Agenda # 21 Street work related to the In City Council August 4 1980
MIT Utility Distribution Systems
and Chilled Water Mains.

Subject: East Campus Utility Distribution Systems

Reference: EAST CAMPUS UTILITY DISTRIBUTION SYSTEMS

Reference: WEST CAMPUS CHILLED WATER MAINS

TYPICAL TRENCH DETAIL
N.T.S.

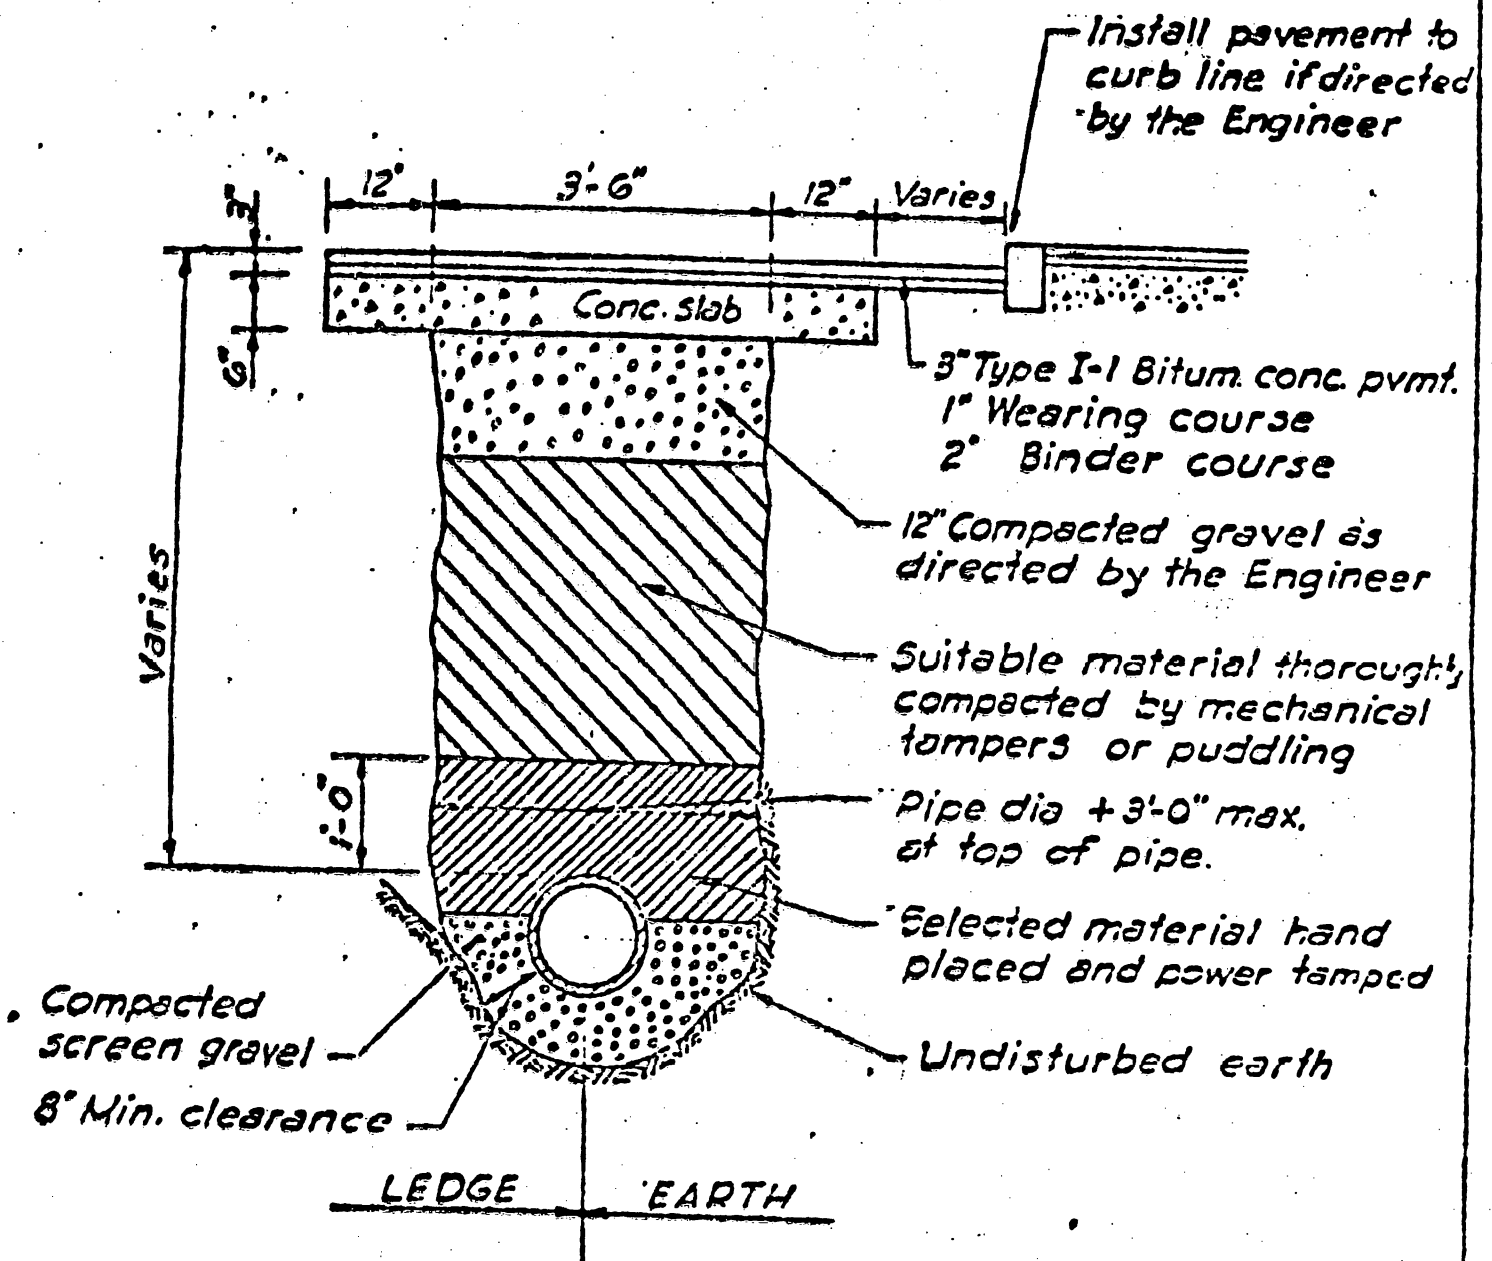
- b) The new 8-inch water main should have a minimum clearance of 12-inches between it and other utilities.
- c) The restoration of the roadway surfaces particularly in Carleton Street will be difficult to accomplish because of the large number of pavement cuts and trench excavations. All of the street restoration work will be subject to approval of Street Superintendent Robert McElroy; and for this reason it is suggested that your utilities contractors meet with Mr. McElroy prior to construction. The City standard trench detail is enclosed for forwarding to your contractors.

TYPICAL TRENCH DETAIL

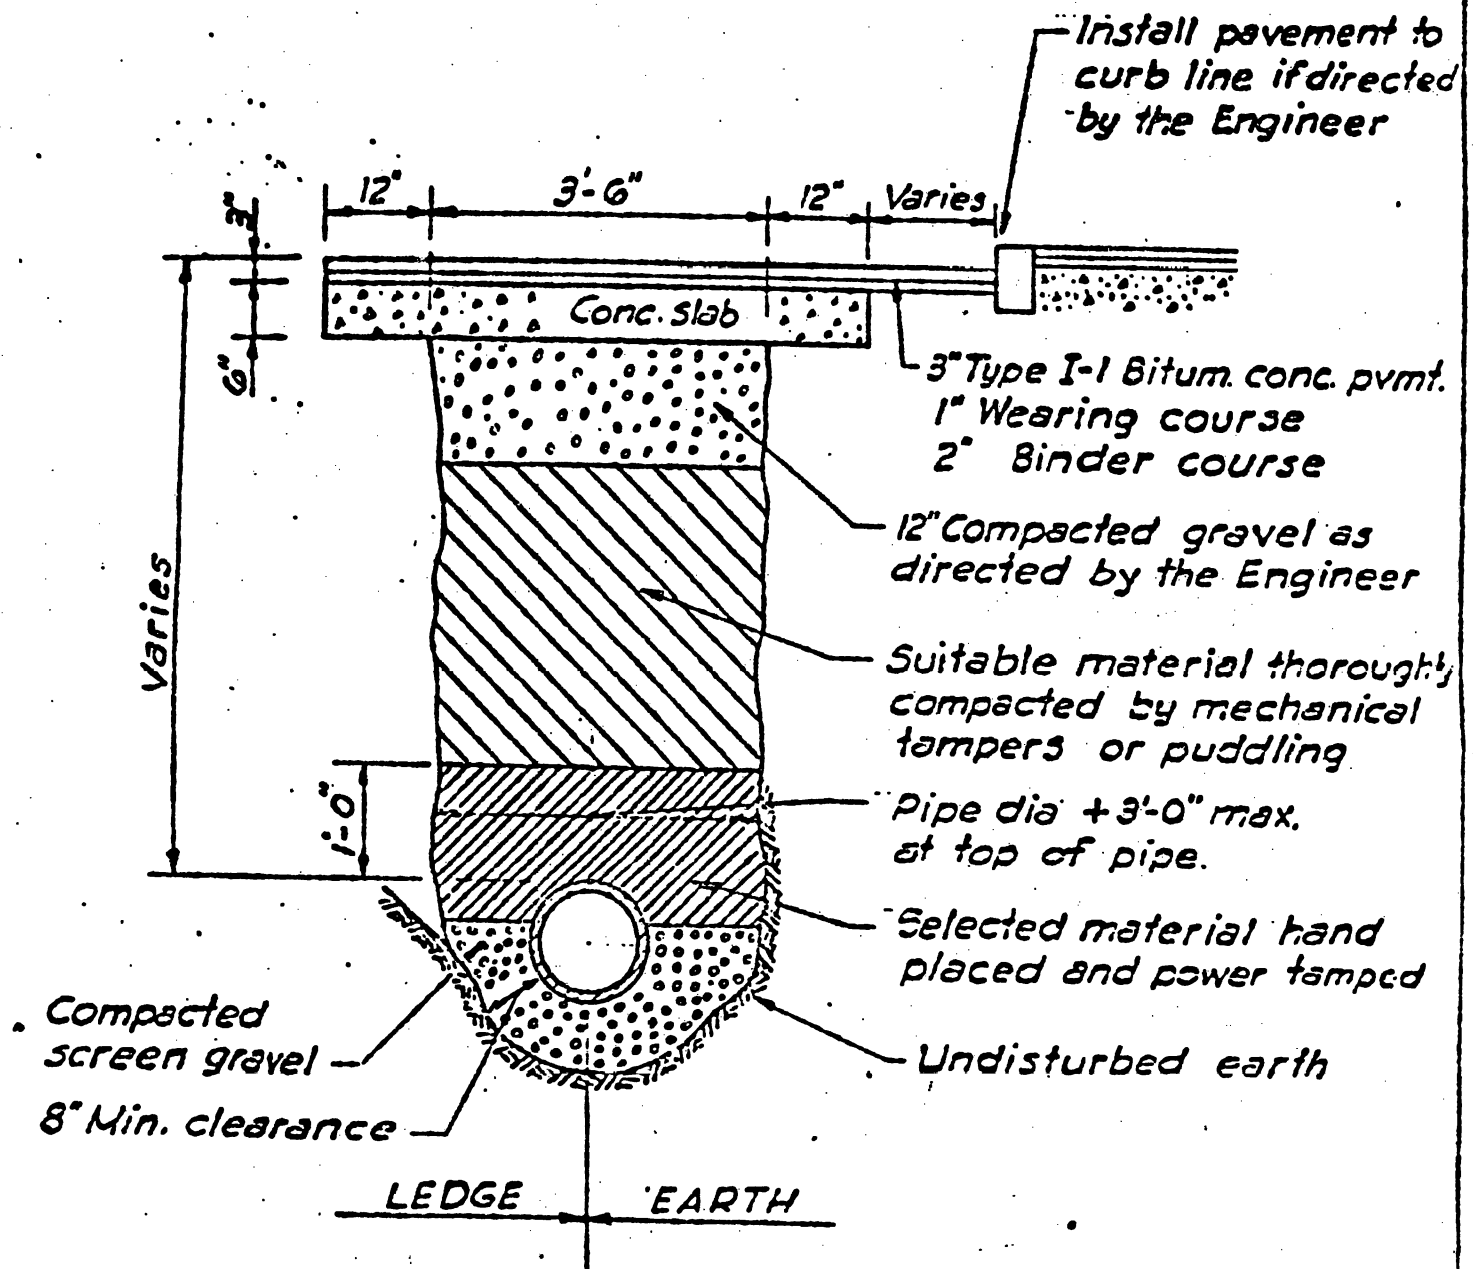
- a) The utility plan for Mass. Avenue fails to show an existing 15-inch sanitary sewer on the east side of the R.O.W. that crosses the street near the proposed location of the M.I.T. chilled water lines. This sewer discharges into the existing 15-inch sanitary sewer located on the west side of Mass. Ave., as indicated on the enclosed City Sewer Plan No. 3. The new chilled water lines crossing Mass. Avenue should not be situated directly over this existing 15-inch sanitary sewer. City Water Plan D-7 has also been enclosed for your information.
- b) A 6-inch concrete slab under the bituminous concrete pavement in trench areas is required at Mass. Avenue and Vassar Street (see attached detail).
- c) Minimum clearances between the chilled water lines and City utilities are 12-inches at water mains and 8-inches for storm drains and sanitary sewers.

TYPICAL TRENCH DETAIL

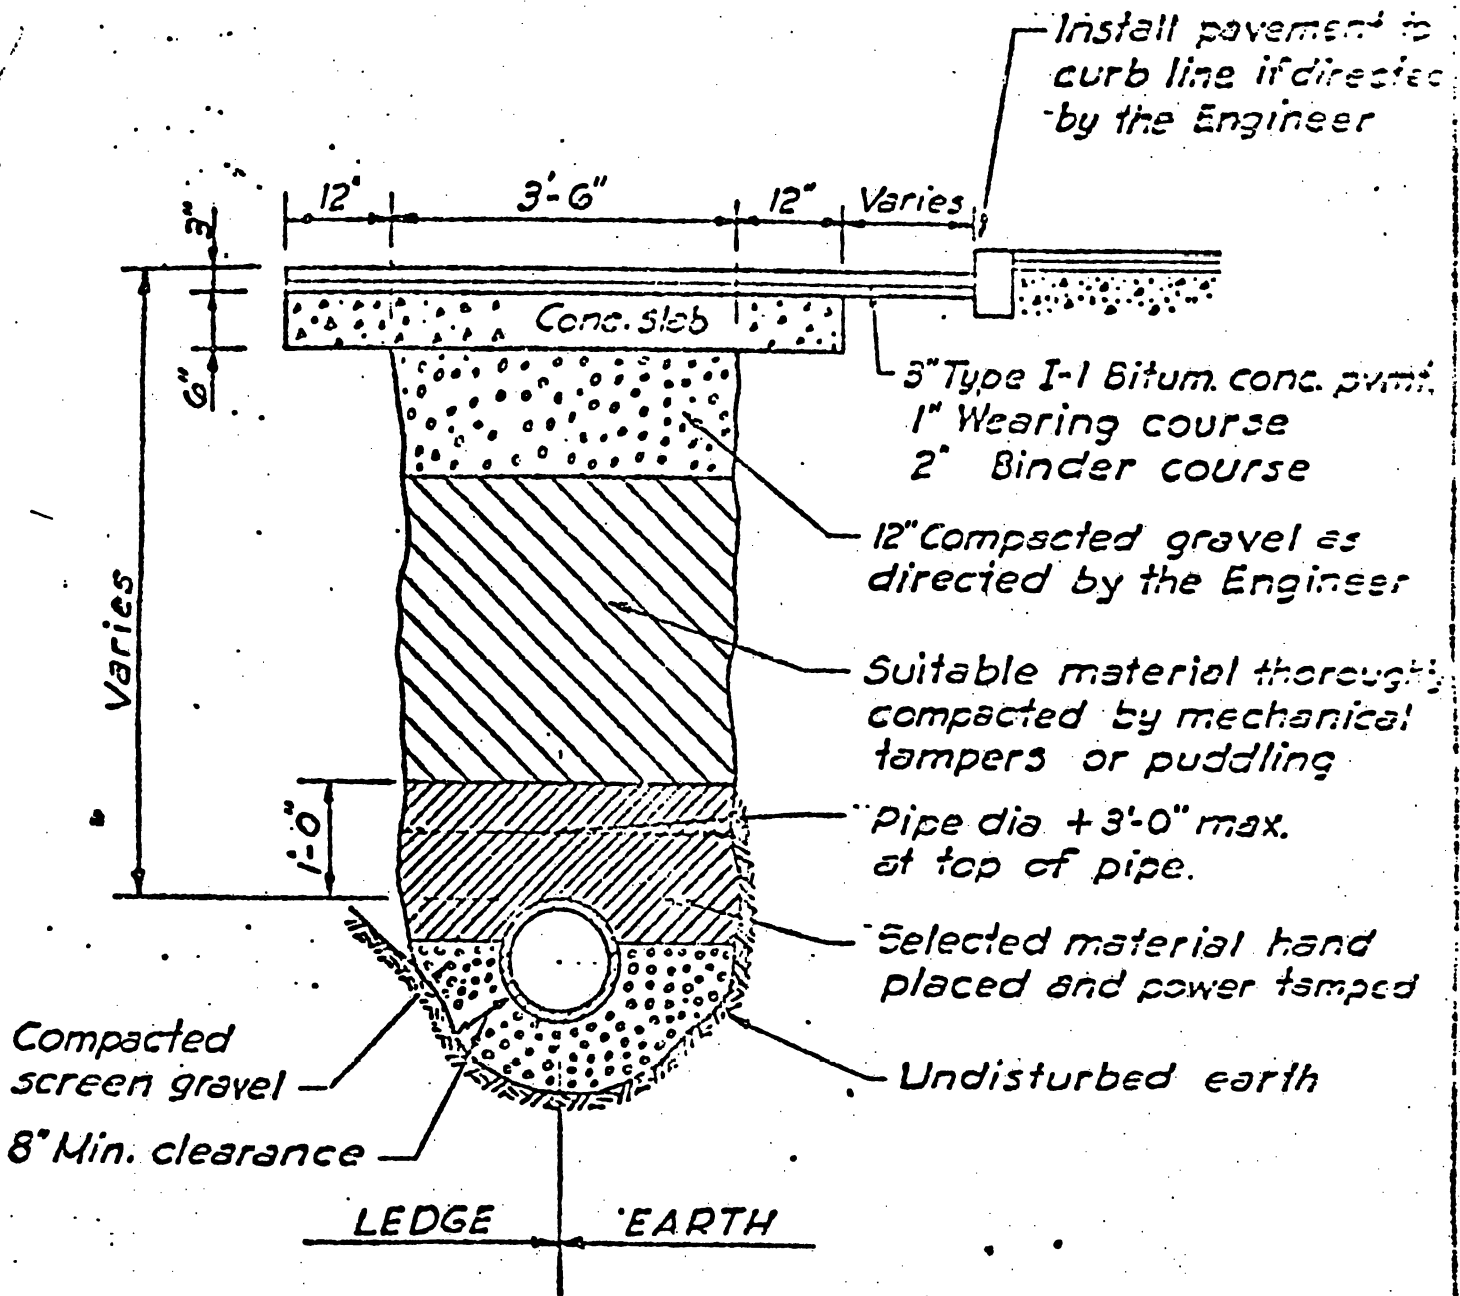
2. The roadway construction standards of the City for all pipe line installation require a 6-inch cement concrete slab over the trench beneath the bituminous concrete pavement as indicated on the attached detail.
